RE: **Warehouse, 4455 Anaheim  
Grading and Drainage Plan  
Engineer's Stamp Date 6-11-2015 (File: C17-D123)**

RE: **Warehouse, 4455 Anaheim**  
**Grading and Drainage Plan**  
**Engineer's Stamp Date 5-13-2015 (File: C17-D123)**

**DRAINAGE REPORT**

**4455 ANAHIEM  
Albuquerque, New Mexico**

Site Grading and Drainage Plan

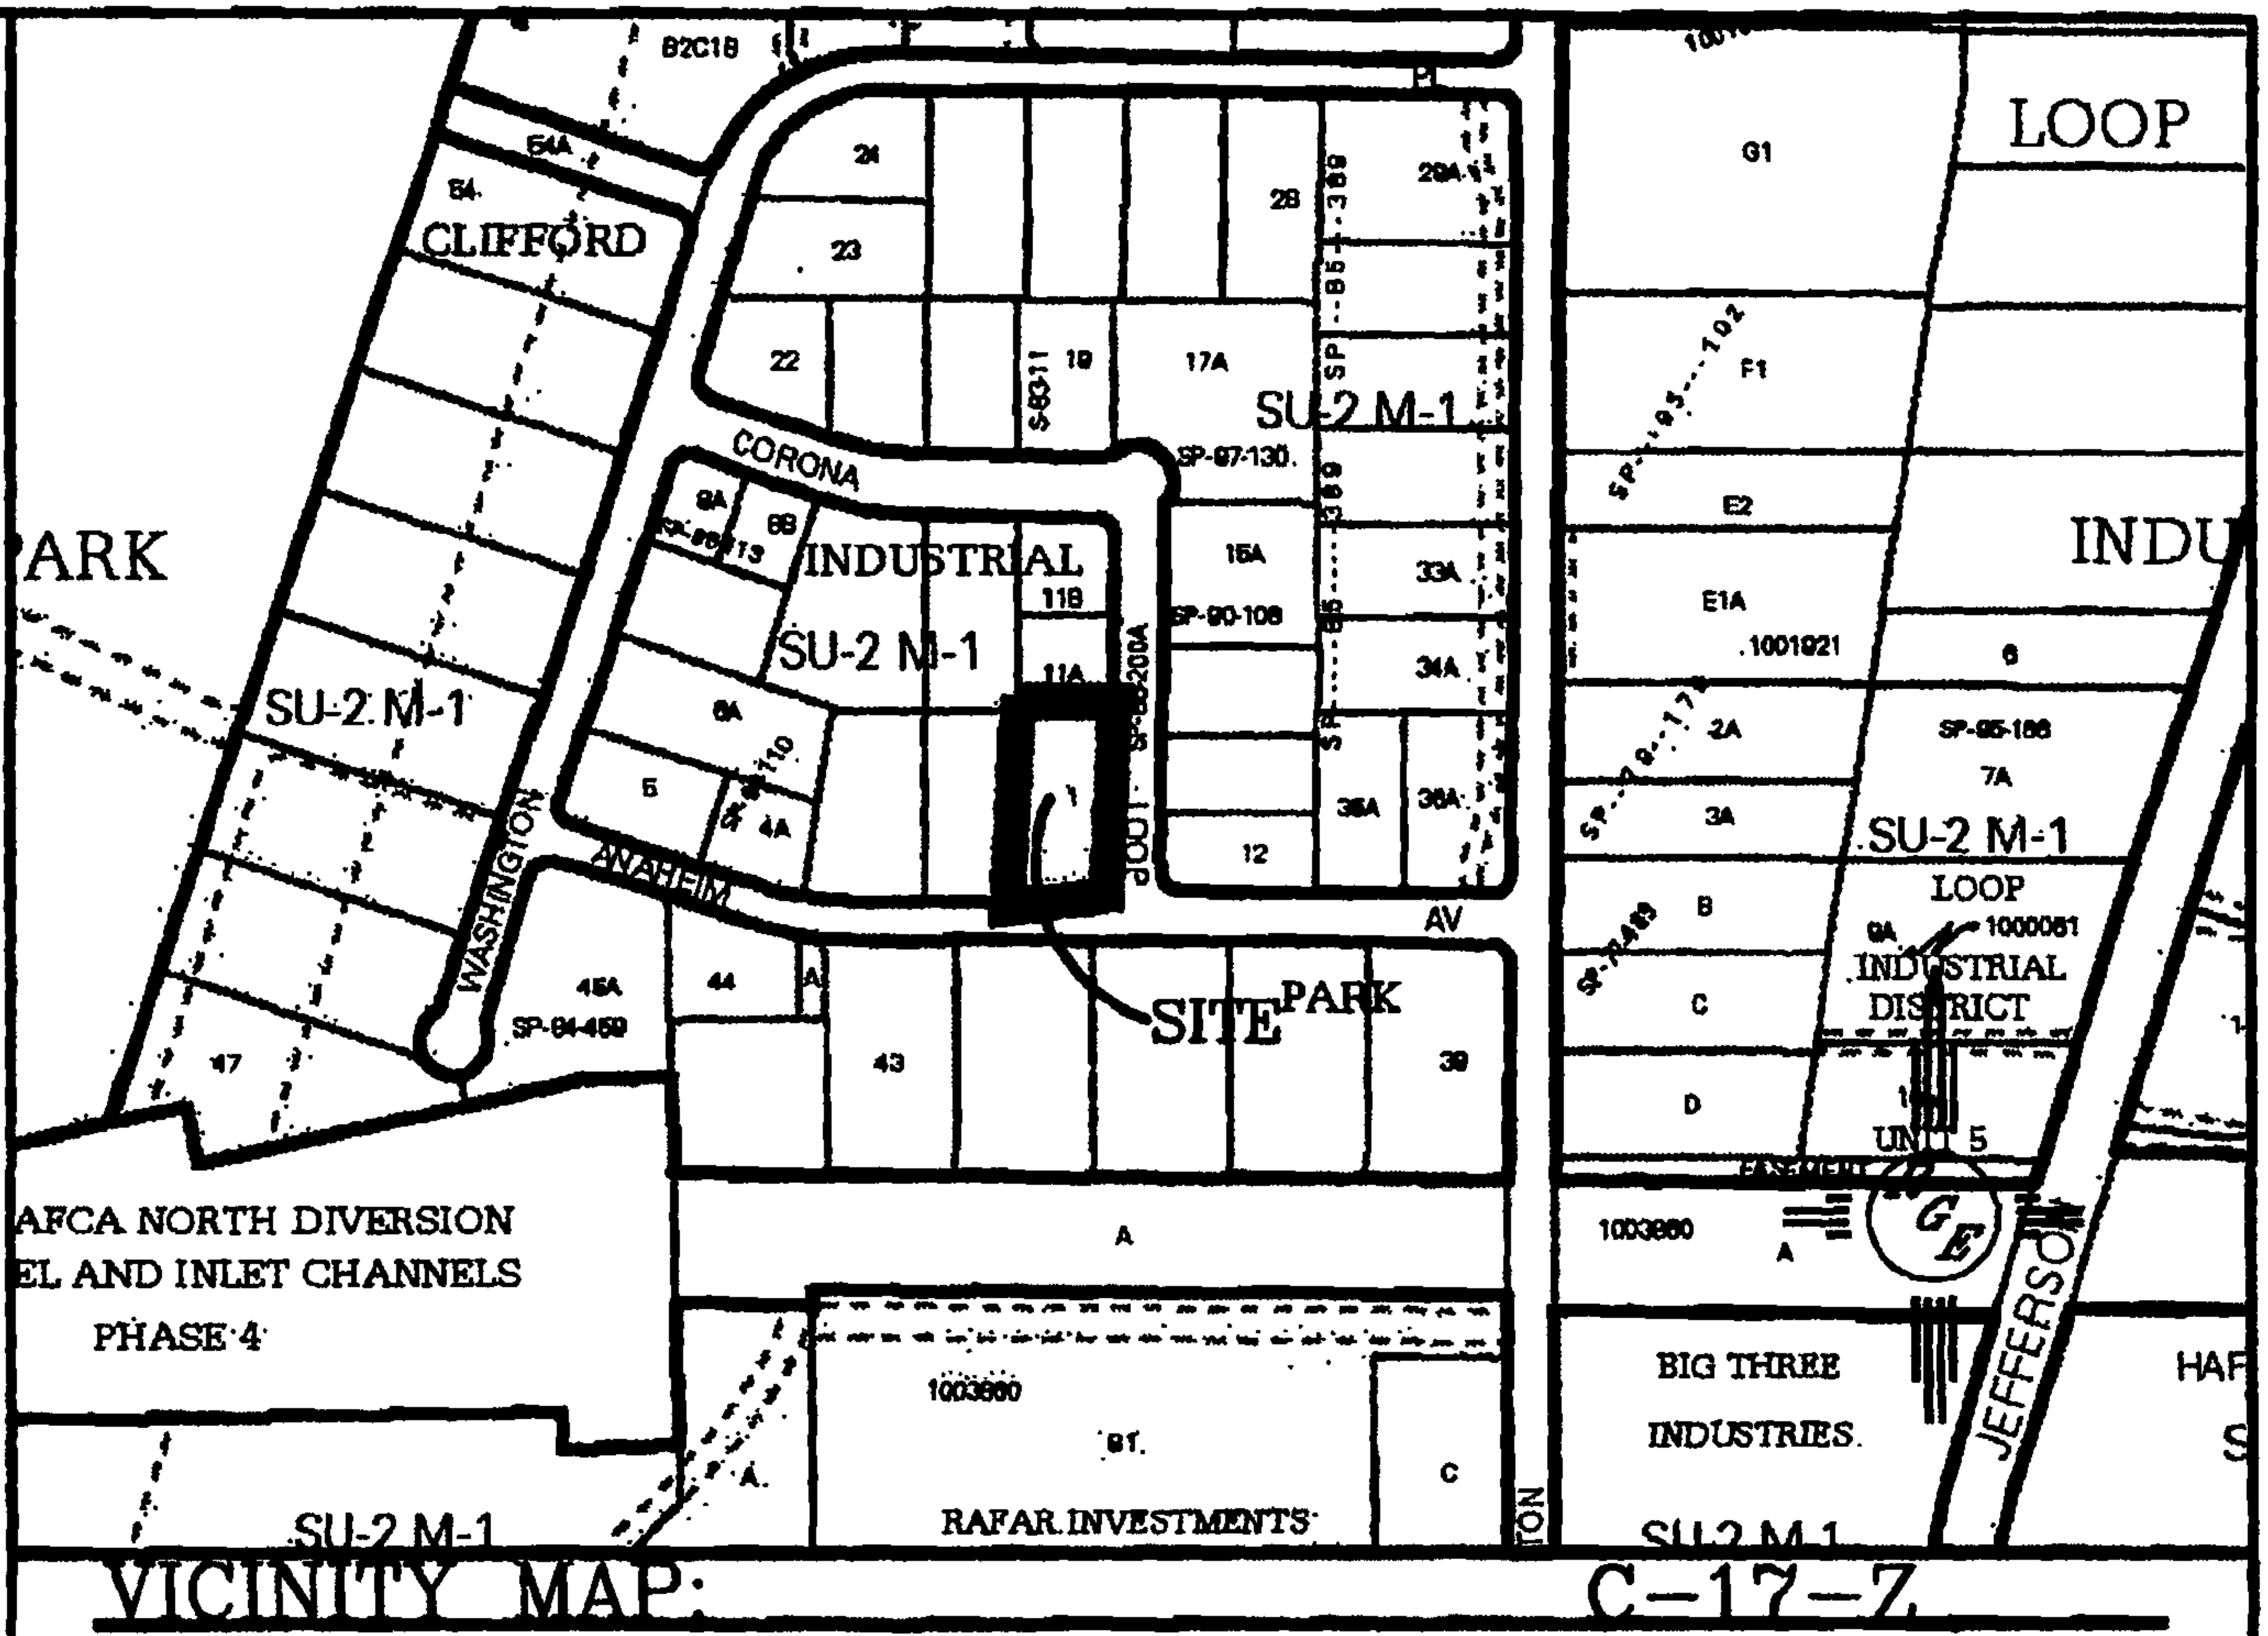
- 1) Provide new and existing curb linetypes and building boundary within legend. Label any gravel areas as "gravel" and paved areas as "paved", and count gravel lot areas as land treatment type "C". Label any new curb and curb height on the plan view as applicable. **We have label the apphalt and curbs**

- 2) Show roof drain locations. **We have added direction and downspouts**
- 3) Show existing spot elevations for curb on Corona Loop and on Anaheim Avenue. Label proposed contours, and additionally provide boundary lines around each of the pond areas that define the top and bottom elevations of the pond. For the three retention ponds, indicate that they are for the "first flush" if this is the case. If new spot elevations provided are at flowline of curb, provide general note stating this. **added spots. line tyoes. labeled ponds. note #1 states spots flowline**

- 4) Correct minor discrepancy in the drainage report which shows a discharge of 2.93 cfs under "Proposed Conditions" discussion and 2.36 cfs under "Summary and Recommendations". **corrected report**

- 5) For existing conditions analysis, it is recommended to analyze the parking lot as "C" land treatment as a compacted lot. This results in less of a difference shown for proposed discharge of the site versus existing discharge.

We have updated existing to type C
